CERTIFICATE OF APPROPRIATENESS

Property: 424 Euclid Street, Lot 6, Block 12, Woodland Heights Subdivision. The property includes a historic 1,623 square foot, one-story wood frame single-family residence, detached rear shed, and a detached rear garage situated on a 5,000 square foot (50' x 100') interior lot.

Proposal: Alteration – Addition *Resubmittal*

NORTH ELEVATION – FRONT FACING EUCLID STREET

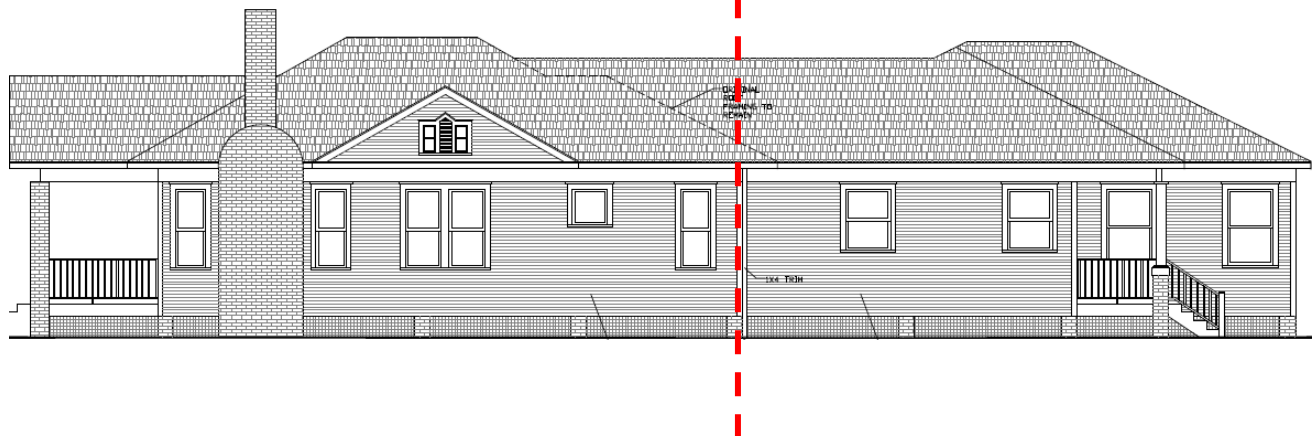
Non-original front porch enclosure, windows, and door to be removed

EAST SIDE ELEVATION

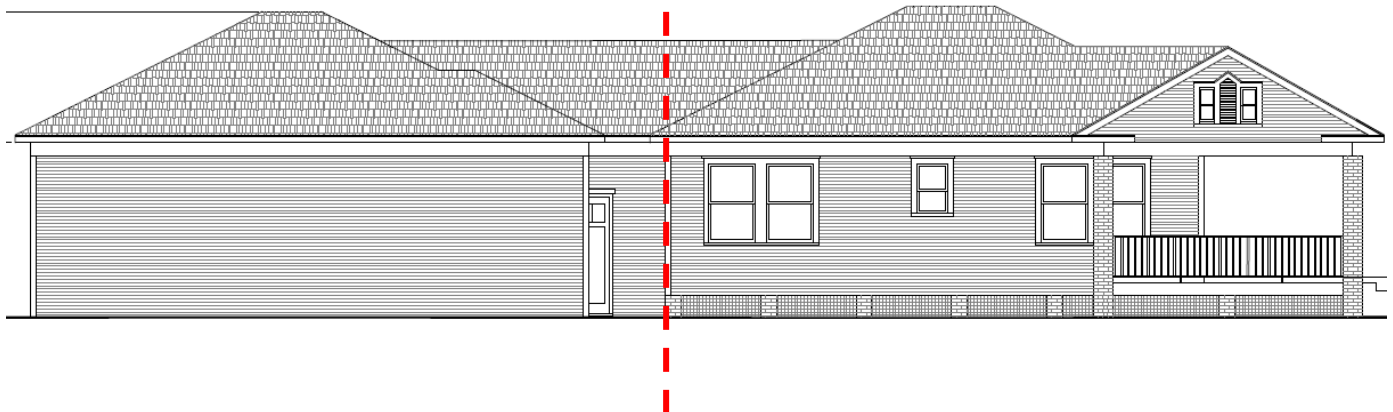
Non-original front porch enclosure, window, and side addition to be removed

SITE PLAN

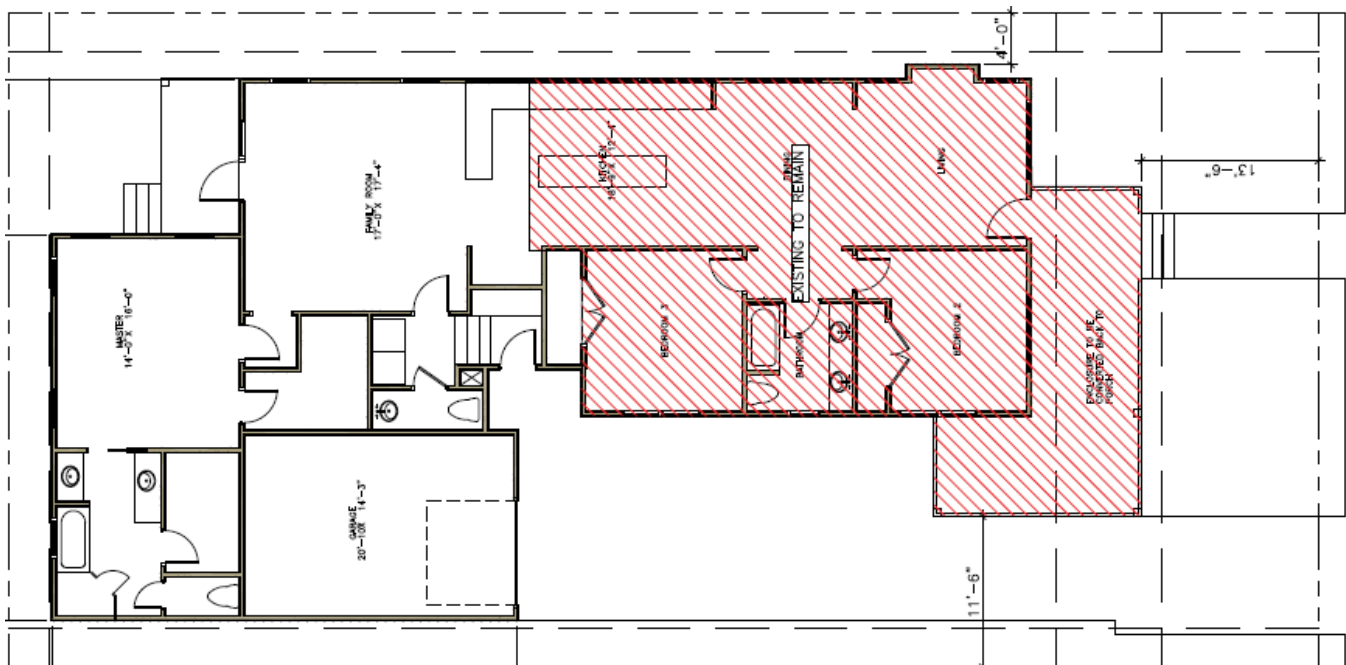
Insetting the addition at the southwest corner of the existing residence would preserve the original rear corner as well as the existing roofline which contribute to the historic character of the residence. Staff finds that if the addition was inset between 6" and 1' rather than flush at the southwest corner, the existing roofline would be retained and the addition would be better

<i>The proposed one-story addition alters the form of the hipped roof at the southwest corner of the original residence, which alters the character of the Craftsman residence. If the addition was inset at the southwest corner, the existing roofline would be retained and the addition would be better delineated. Staff believes the addition would then meet Criterion 1.</i> |

<i>Not insetting the addition at the southwest corner of the original residence alters the form of the hipped roof. If the addition was inset at the southwest corner, the existing roofline would be retained and the addition better delineated. Staff believes the addition would then meet Criterion 4.</i> |

<i>Although the addition begins at the original rear wall, the portion of the addition at the southwest corner results in an alteration to the existing roof structure that alters the essential form. If the applicant inset the addition at the southwest corner, the rear corner would be left intact to better delineate between the original structure and the proposed addition, and the form of the existing roof structure would be retained. If the addition was inset at the southwest corner, the addition would be better delineated. Staff believes the addition would then meet Criterion 8.</i> |

Recommendation: Approval with conditions: Approval with the condition that the applicant inset the addition between 6" and 1' at the southwest corner of the original residence
